SPI Parallel Read Operation on GBB (1722c)

Adriaan Niess, XC/EYA2, 2024-08-27

Consecutive SPI Read (1722b)

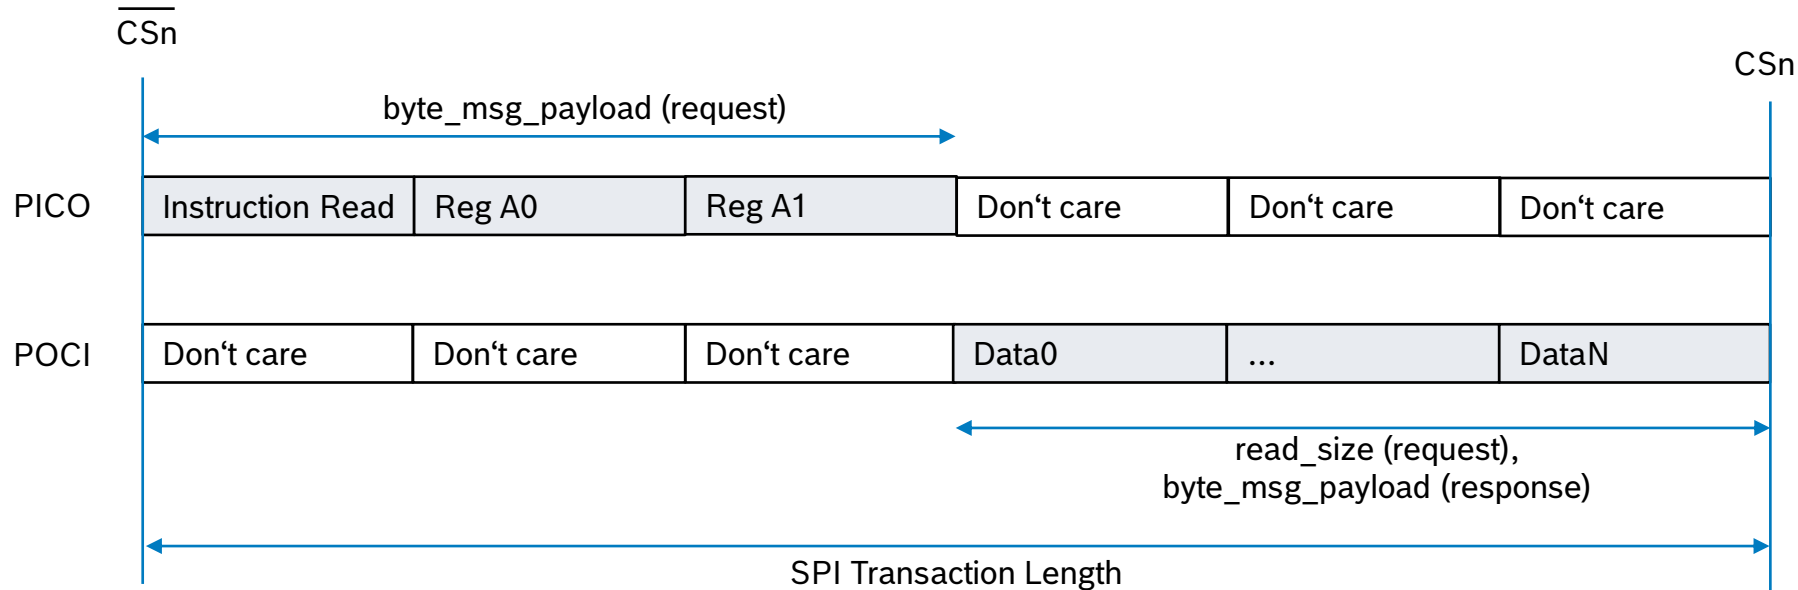
- Proposal: If $\text{op}==0$ and $\text{hs}==0$ a **Consecutive Read** operation is performed
- Total length of SPI transaction is $(\text{byte_msg_payload} + \text{read_size})$
- **If $\text{hs}==0$, the GBB read_size is aligned to the first byte following the end of the write phase**
- To my knowledge, this is basically Hari's proposal(?) and should cover >90% of use cases

Proposal: Parallel SPI Read (1722c)

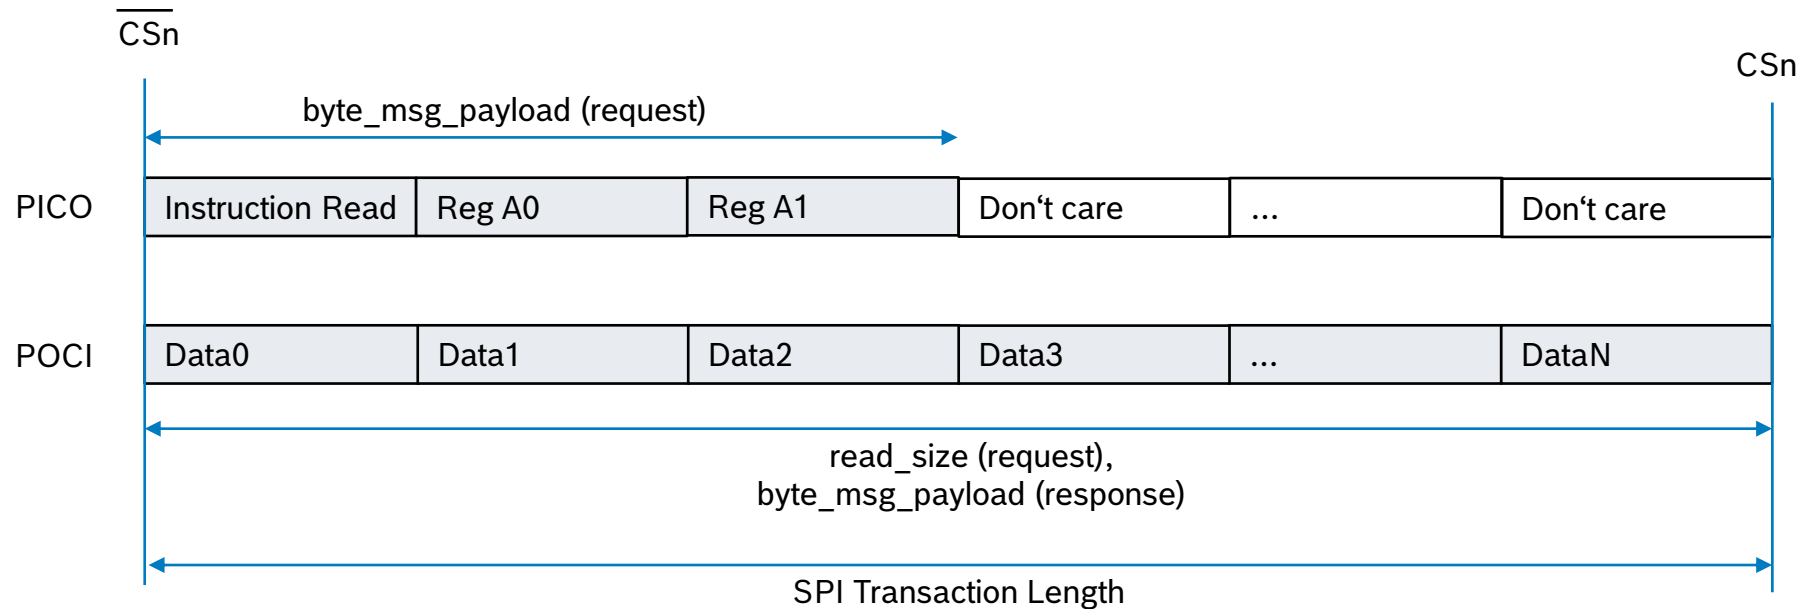
- Proposal: If $\text{op}==1$ and $\text{hs}==1$ a **Parallel Read** operation is performed
- Total length of SPI transaction can be calculated as $\text{MAX}(\text{request_payload_size}, \text{read_size})$
- **If $\text{hs}==1$, the GBB read_size is aligned to the first byte of the SPI transaction**
